CITY OF PALM BEACH GARDENS

Addendum No. 6

SOLICITATION NO.: ITB2021-137GF

TITLE: Construction of Par 3 Golf Clubhouse at Sandhill Crane Golf Club

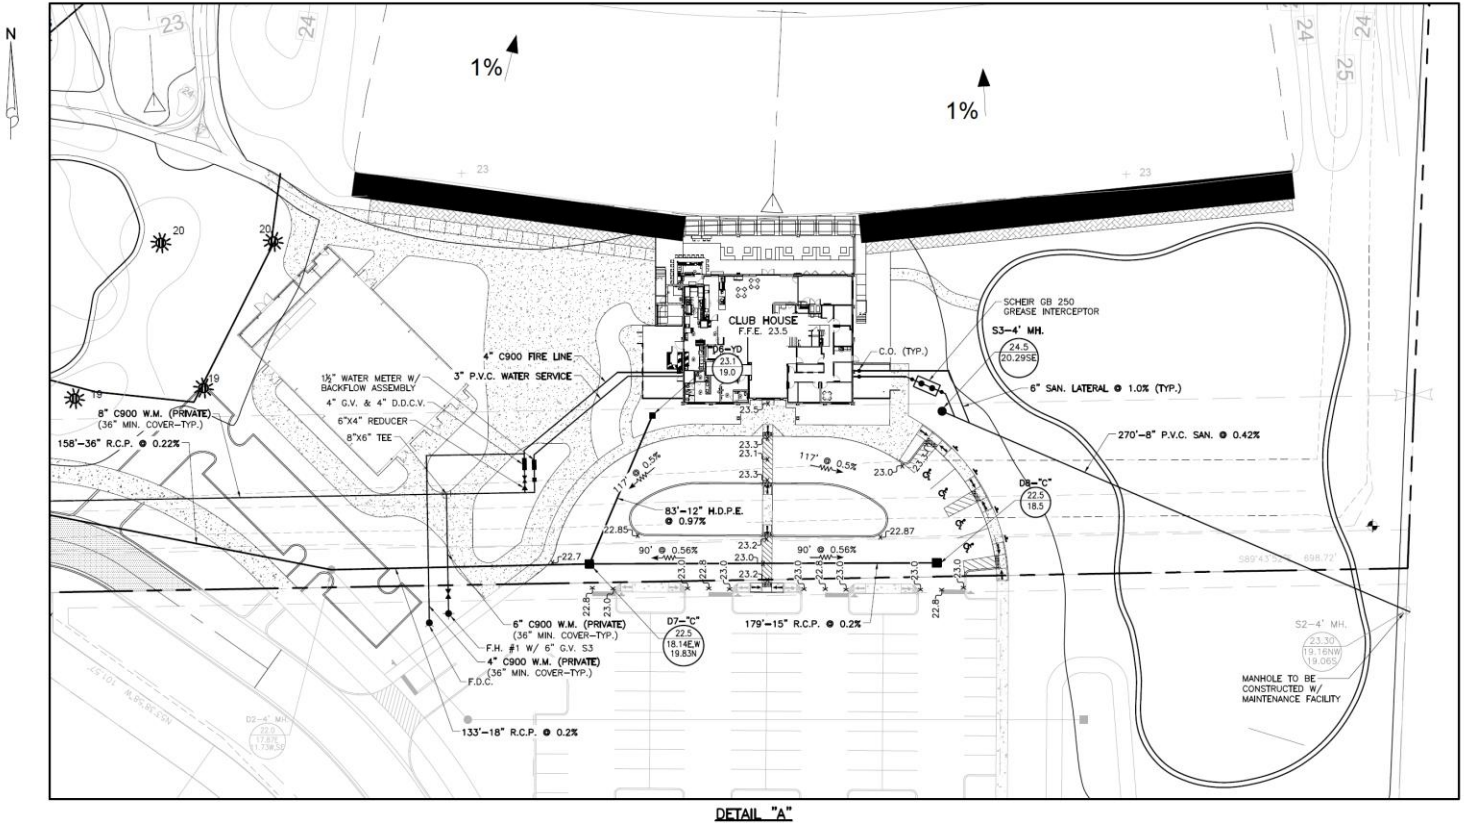
Question 25: What is the grade at building edge?

Response: *The finished floor elevation (grade) of the building is hereby amended to read 24.5 NAVD. The edge of the building elevation will depend on the side. See below Detail A from the draft civil plans. All doors will be ADA accessible and require a taper of no steeper than 2%. Civil plans will be provided as soon as completed.*
